MEETING: REGULAR MEETING OF THE PLAN COMMISSION

DATE & TIME: Monday, December 9, 2024 at 6:30 PM

- B. Jeff Osgood, Agent for Kwik Trip, Inc., and Ben Venue Properties, Property Owner, N112W18741 Mequon Road (former PNC Bank). Kwik Trip Convenience Store Relocation from W188N10963 Maple Road. Conditional Use Permits (CUPs), Site/Sign Plan, and Rezone from B-3 to B-5. (PUBLIC HEARING & ACTION)

- D. Briohn Building Corp. Agent for TDC Willow Creek LLC Property Owner - N102 W19200 Willow Creek Way. Site Development & Building Plan Application for a 1.55-acre Outdoor Storage Area. (ACTION)

L1.0

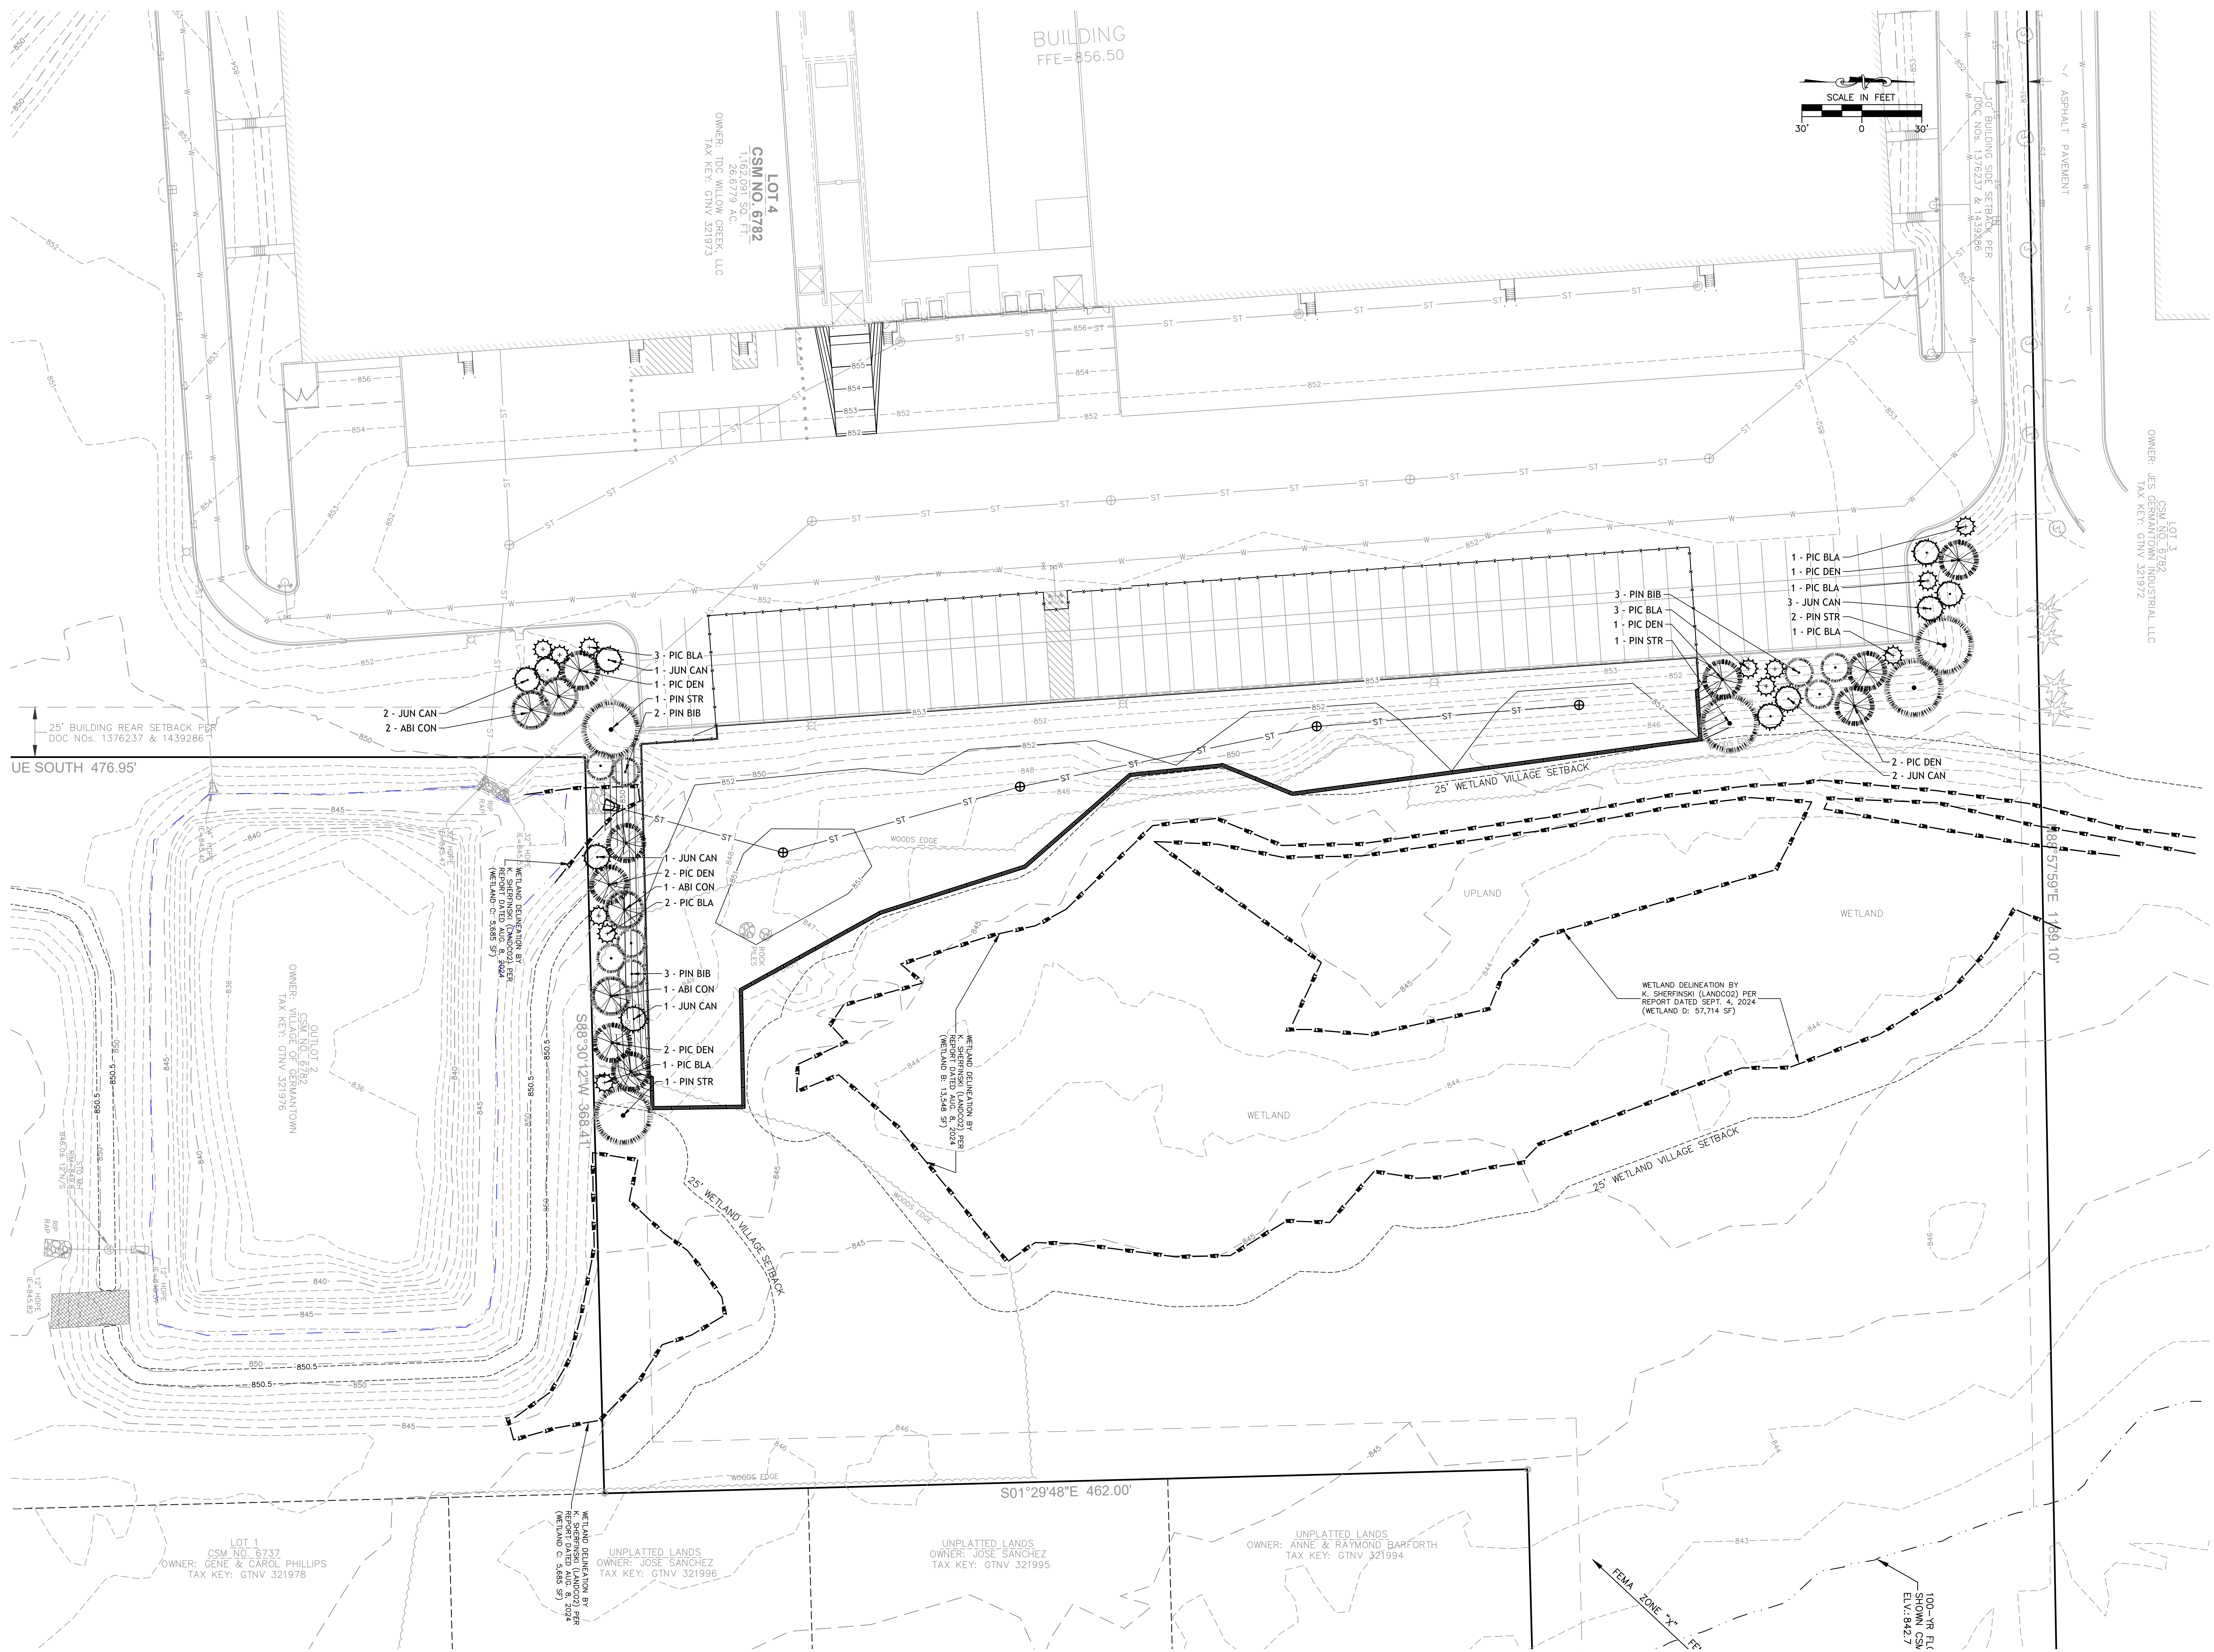
7. The landscaping plan shall be revised to meet the Village's code requirements as set forth below:
 1. Page L1.0. Per municipal code 17.43(c). Interior parking lot landscaping shall include (one) 2" caliper tree for every ten parking spaces.

2. Page L1.0. Per municipal code 17.43(c). Parking lot landscaping of perimeter with plantings around the parking lot for screening from adjacent properties.

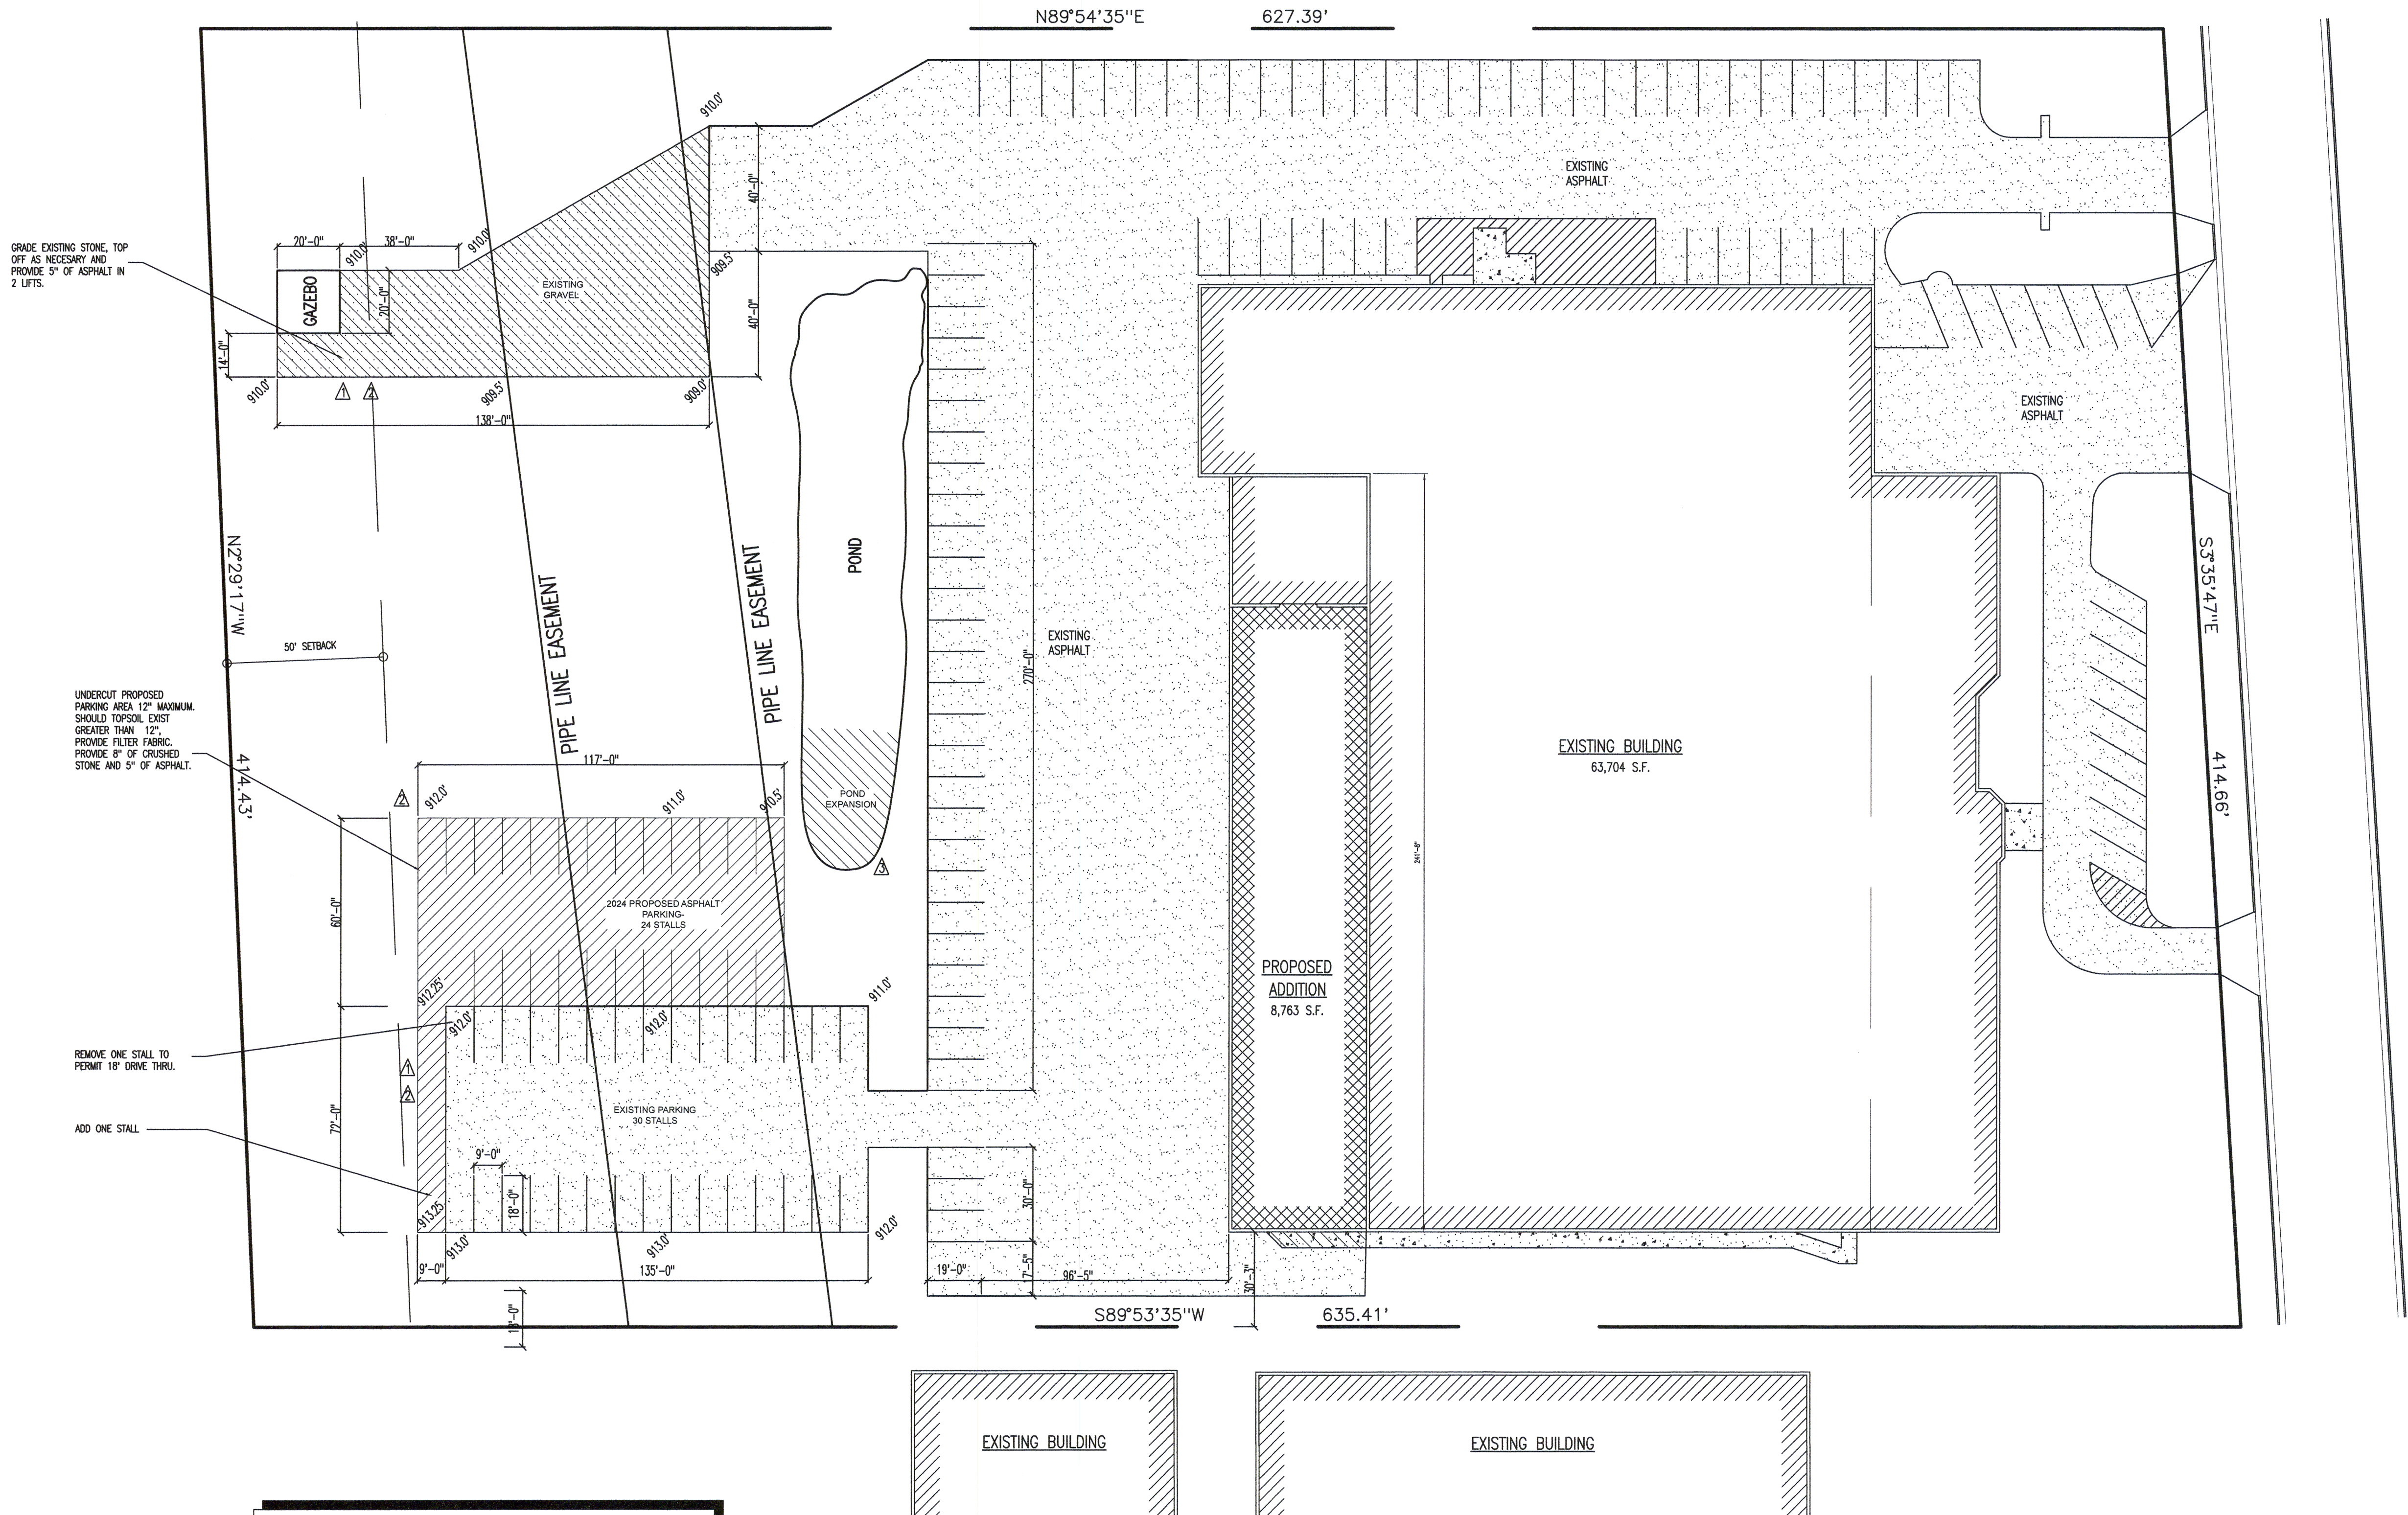
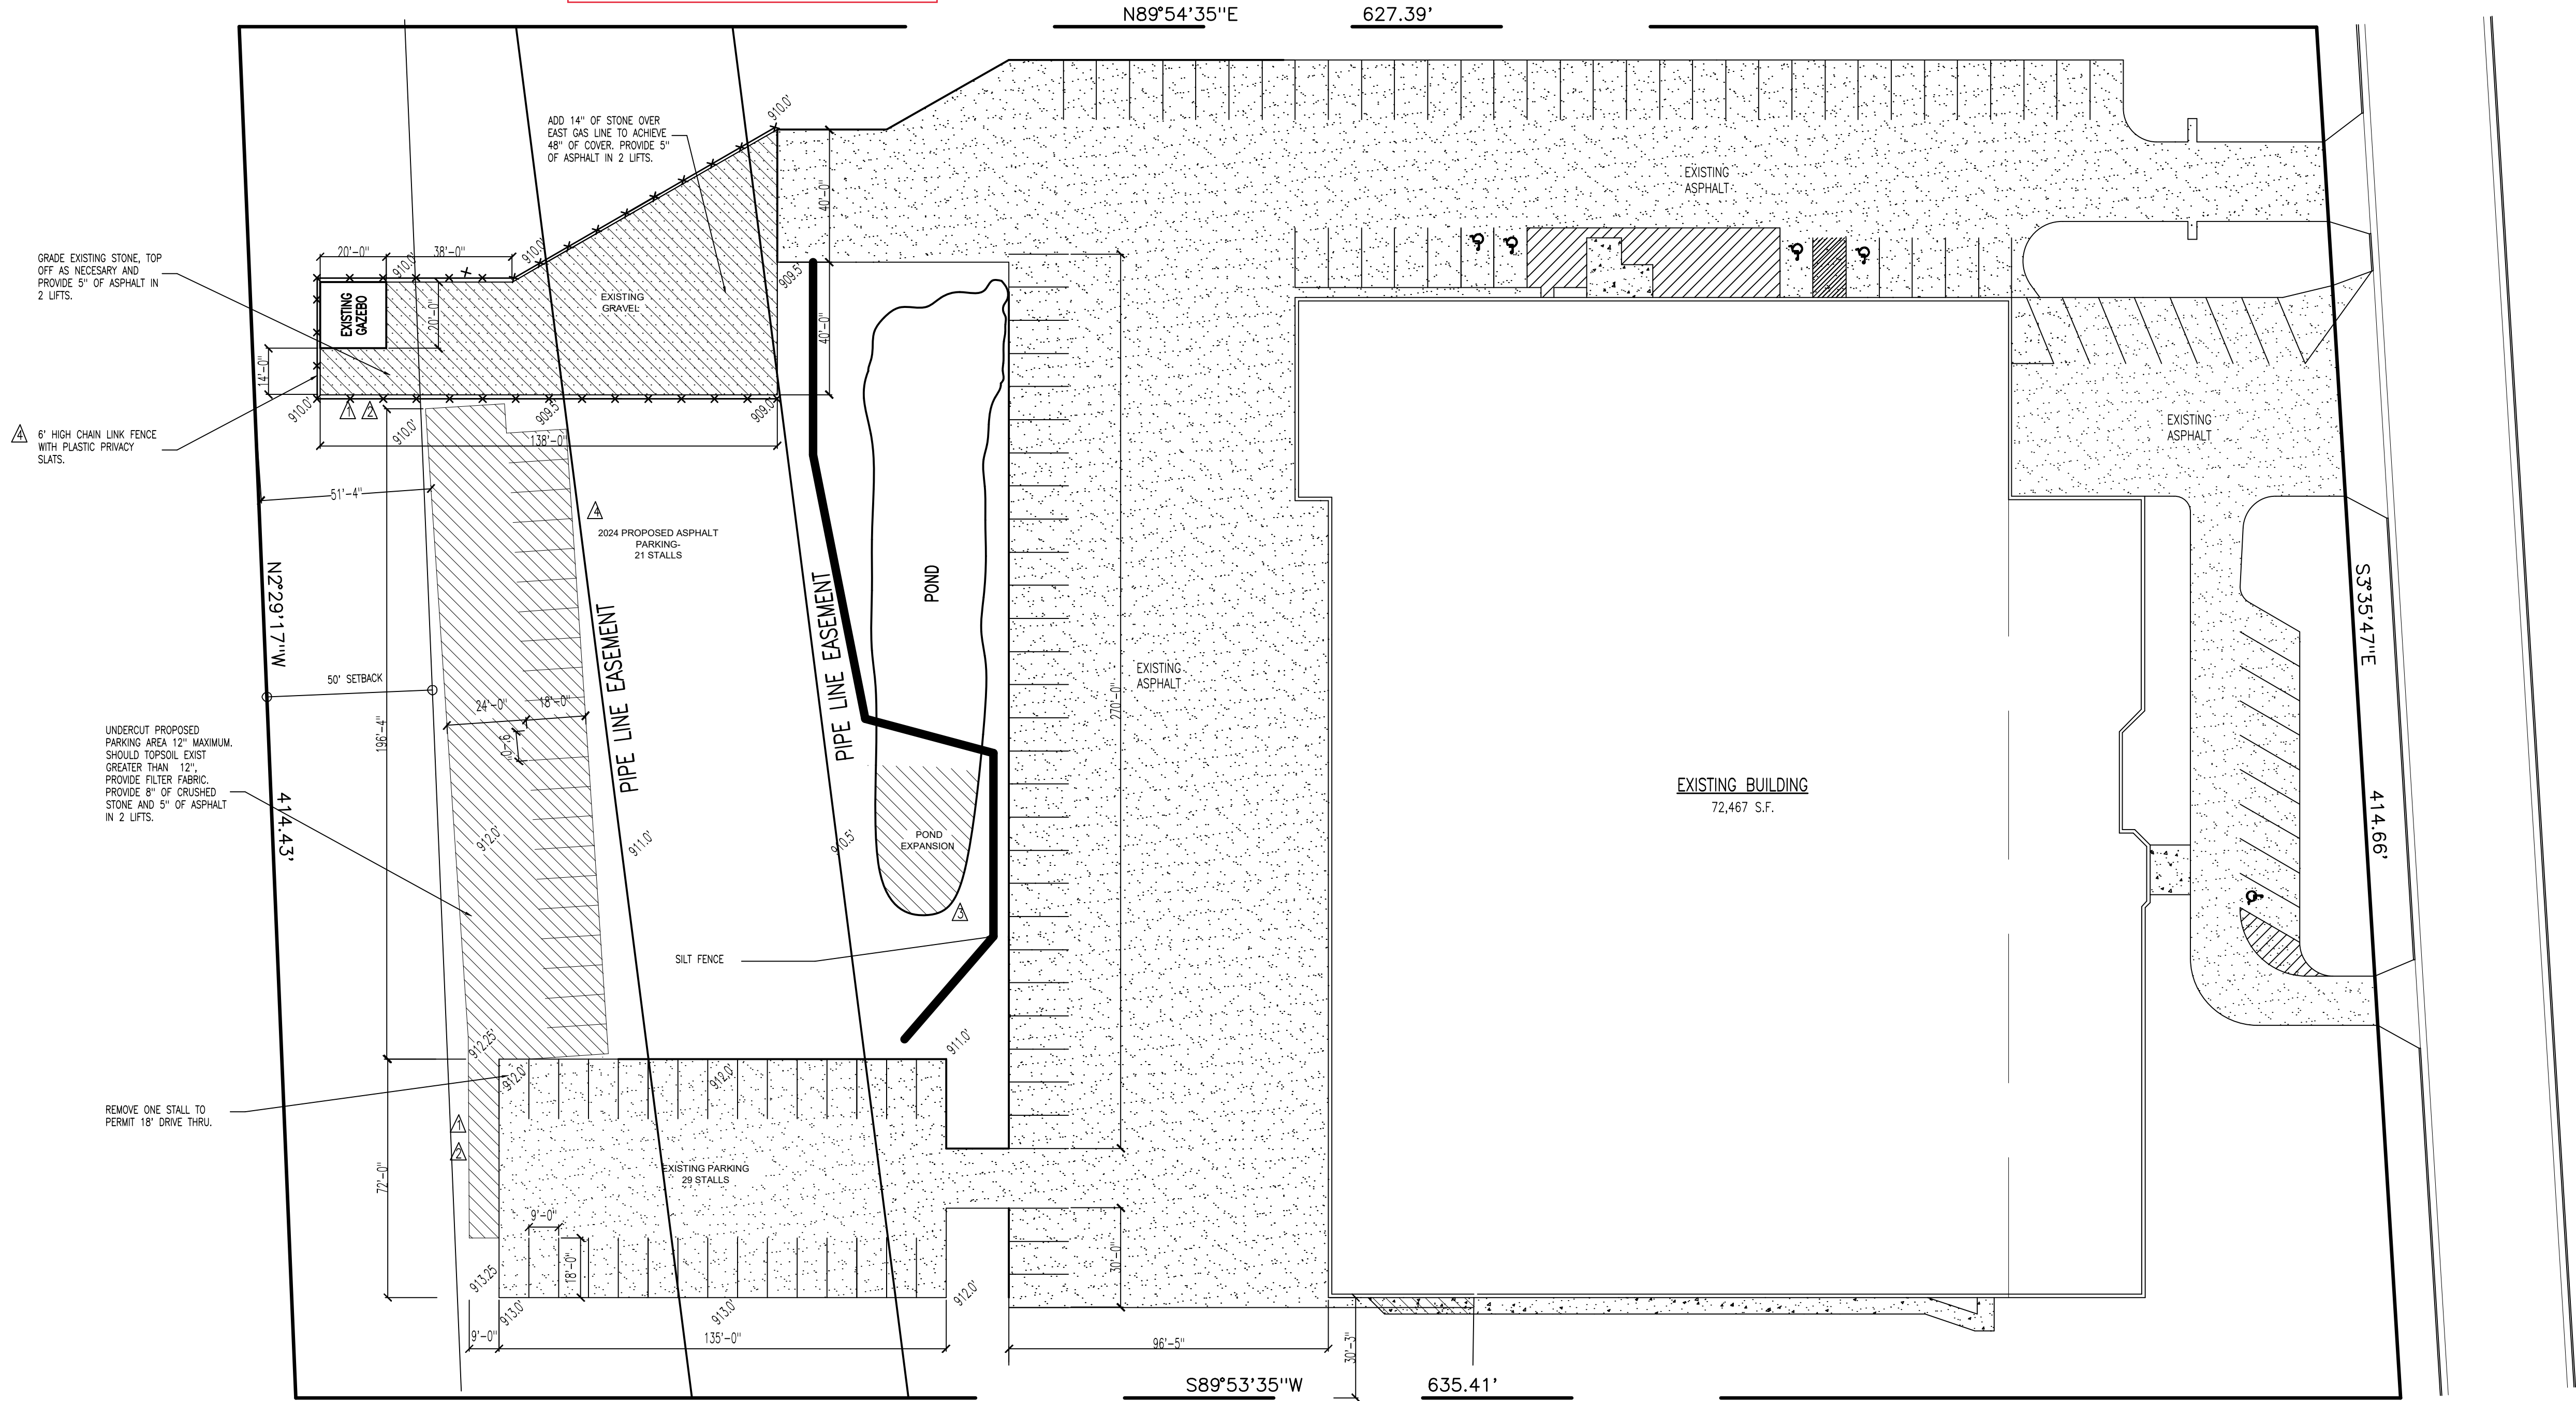
- 1 Revised Site Plan dated March 12, 2024, with latest revision dated 10-30-24.
- 2 Revised Storm Water Management Plan.
- 3 Revised Landscape Plan.
- 4 Original TC Energy Encroachment Agreement, Exhibit A- Engineering Guidelines & Exhibit B Application Information.
- 5 Revised easement agreement conditions with corresponding plan (marked up in red).

No permanent storage
permitted within TCE ROW.
